Addendum 01

MCSD Bid No.: 2025-3
Fremont ES, Hoover MS, Muir ES
Perimeter Fencing Projects

Date: November 13, 2025
TETER Project No.: 25-13173, 25-13360

Merced City School District
444 W. 23rd St.
Merced, CA 95340

A100

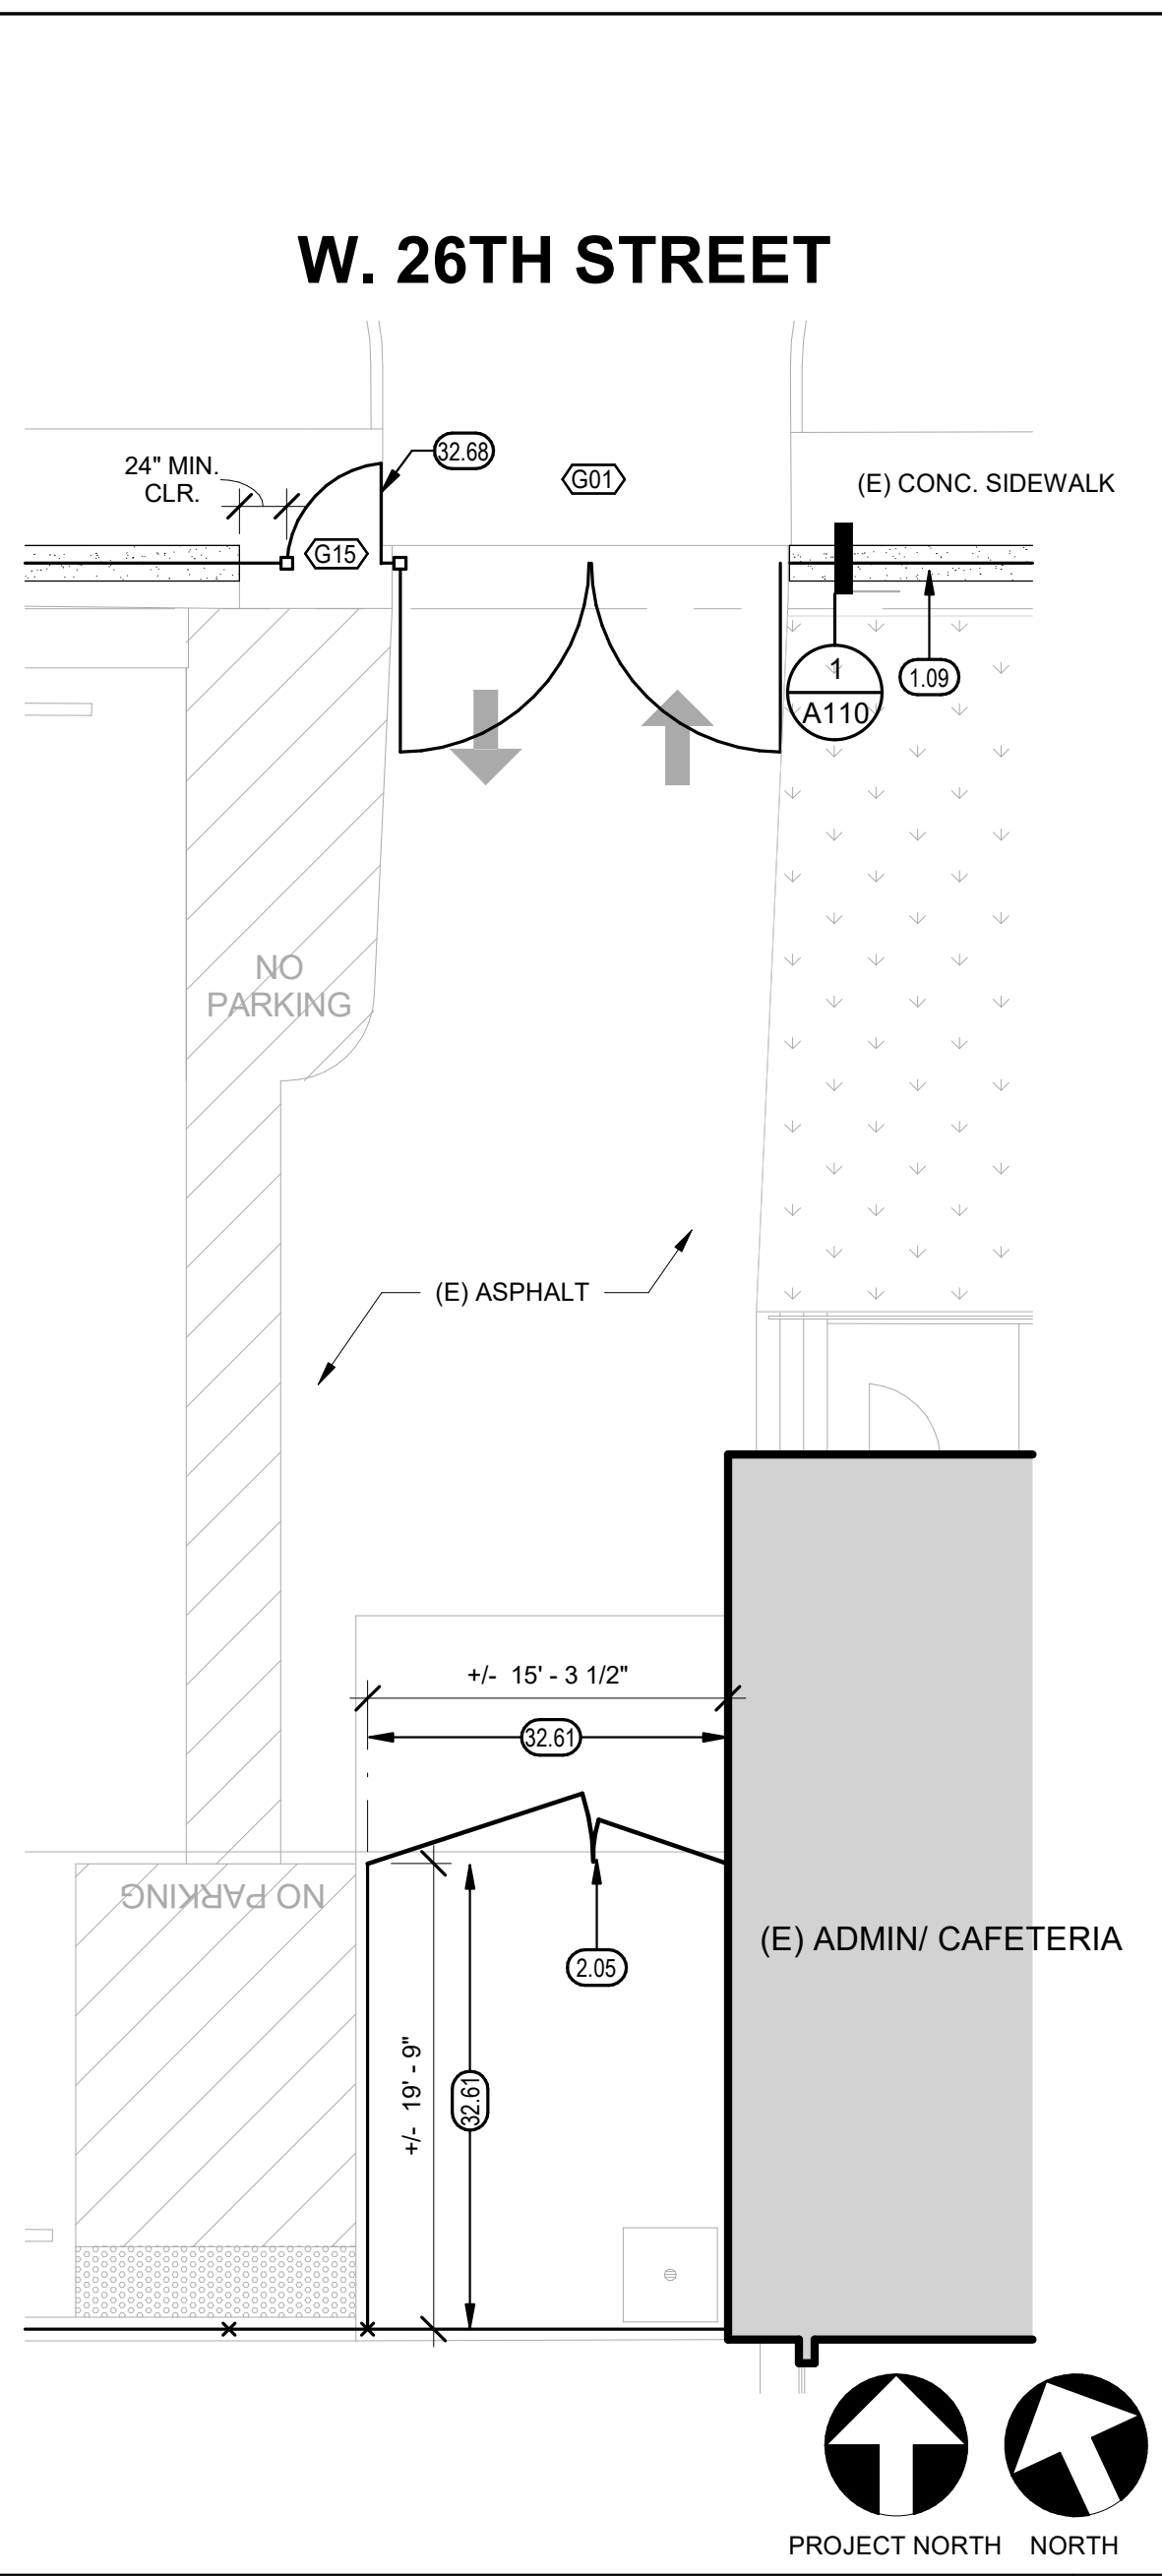
- Z. **Question:** Regarding the Scope of work at Muir ES: At the 100 year old school you mentioned match the new gate that is there with a header - But that's not the detail shown on the plans please confirm that's what will be required at Muir?

- BB. **Question:** Regarding the Scope of work at Muir ES: Please clarify that there are no Knox Boxes required at John Muir ES, the site plan doesn't show any.

Answer: Gate GE1 at the John Muir ES Project site is to include a tube steel header to match the existing gate. See revised Gate Schedule on sheet **A100** and post attachment detail **15/A112** for the John Muir ES project site.

Answer: A Knox Box is required at the new gate G16. See Keynote 10.61 on the revised Sheet A100 for the John Muir ES project site.
- CC. **Question:** Regarding the Scope of work at Muir ES: At gate GE1 is showing as existing but you on the walk mentioned having it replaced to match the new one next to it. Please confirm and or add that to our scope in the addenda.

Answer: Gate GE1 at the John Muir ES Project site is to include a tube steel header to match the existing gate. See revised Gate Schedule on sheet **A100** and post attachment detail **15/A112** for the John Muir ES project site.

ENLARGED SITE PLAN 1/8" = 1'-0" 7

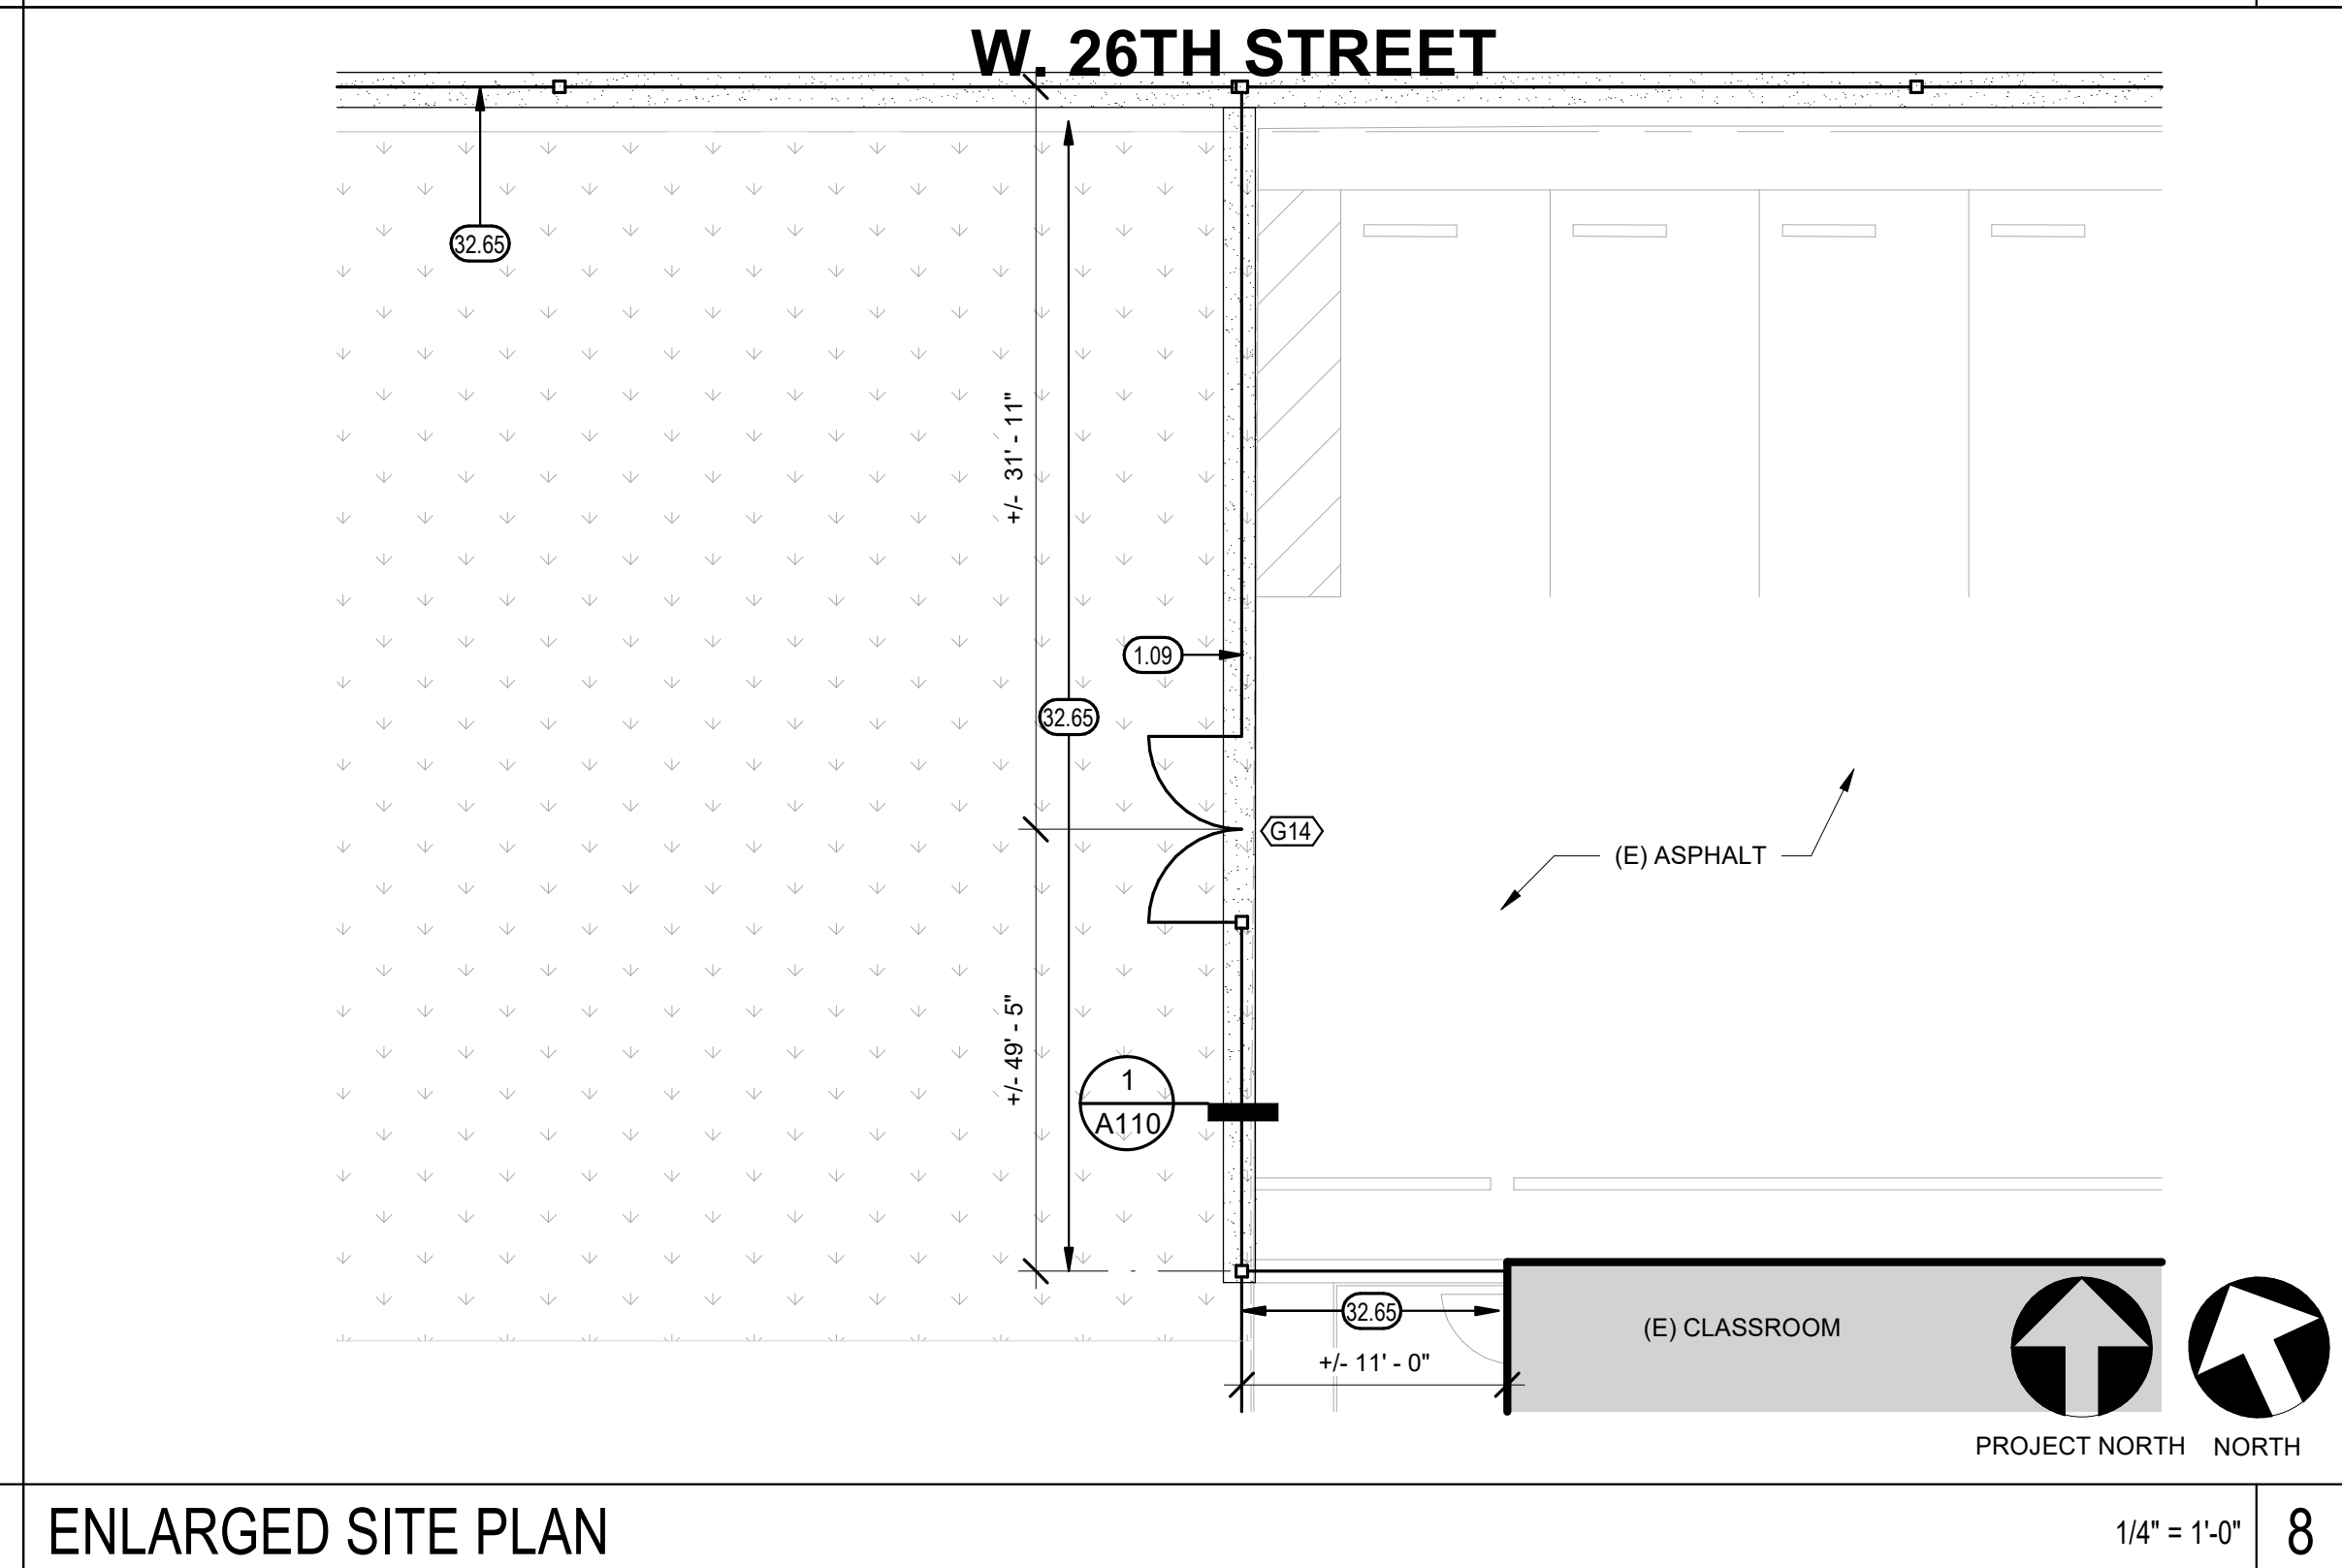
- O. **Question:** Detail 7/A101, there is a 6"W swing gate with no ID and is not in gate schedule. Please confirm this gate is in scope.
Answer: Gate G17 has been added to the Enlarged Site Plan and Gate Schedule. See revised Gate Schedule on sheet **A100** and **7/A101** for the John Muir ES project site.

- P. **Question:** On details 7/A101& 8/A101, there are some dimensions that do not match the scaled values. Please confirm if we are to base our quantities on the dimension values shown on scaled distances. See attachment for dimensions in question.

Answer: See revised sheet **A101** for the John Muir ES project site.
- Q. **Question:** Detail 2/A110 calls for a 2"x12" gate frame. We believe this is a typo and should be a 2"x2" gate frame. Please confirm.

1/2" = 1'-0" 2

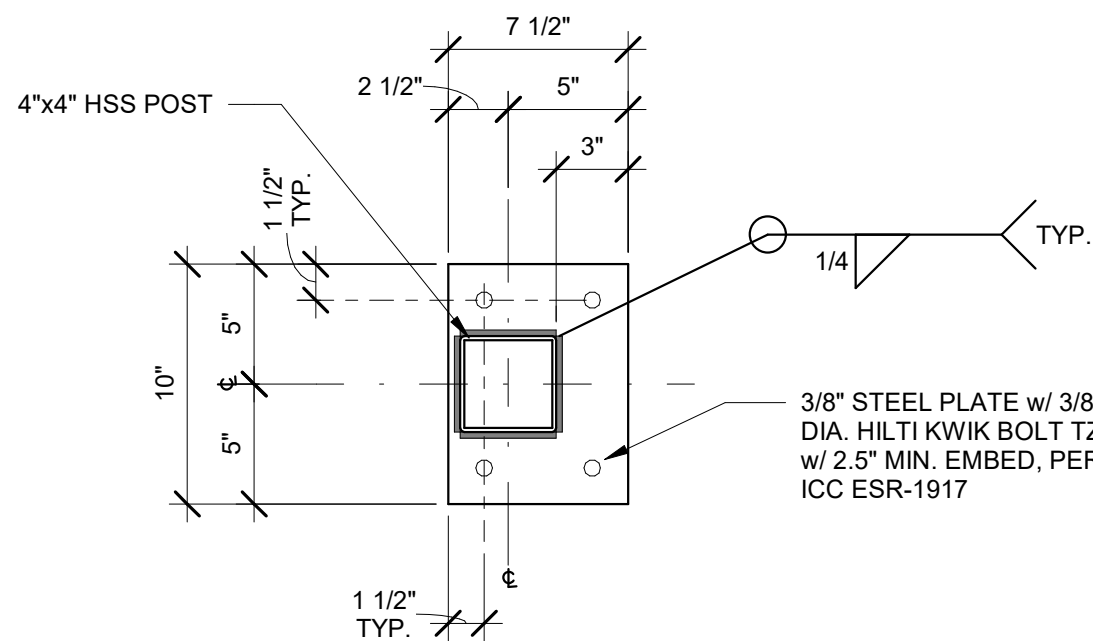
- AA. **Question:** Regarding the Scope of work at Muir ES: Please clarify that there is no accessible signage required at John Muir ES. Detail 2/A112 doesn't call out the "8"x8"x16 GA PLATE WELDED TO PICKETS -FOR ACCESSIBLE SIGNAGE, SEE" on the Ornamental Swing Gate - Accessible detail like Herbert Hoover MS and John Fremont ES does but shows the outline on the push side.

Answer: ISA signage is only required where indicated for gate GE1. See revised Gate Schedule on sheet **A100** and post attachment detail **4/A112** for the John Muir ES project site.
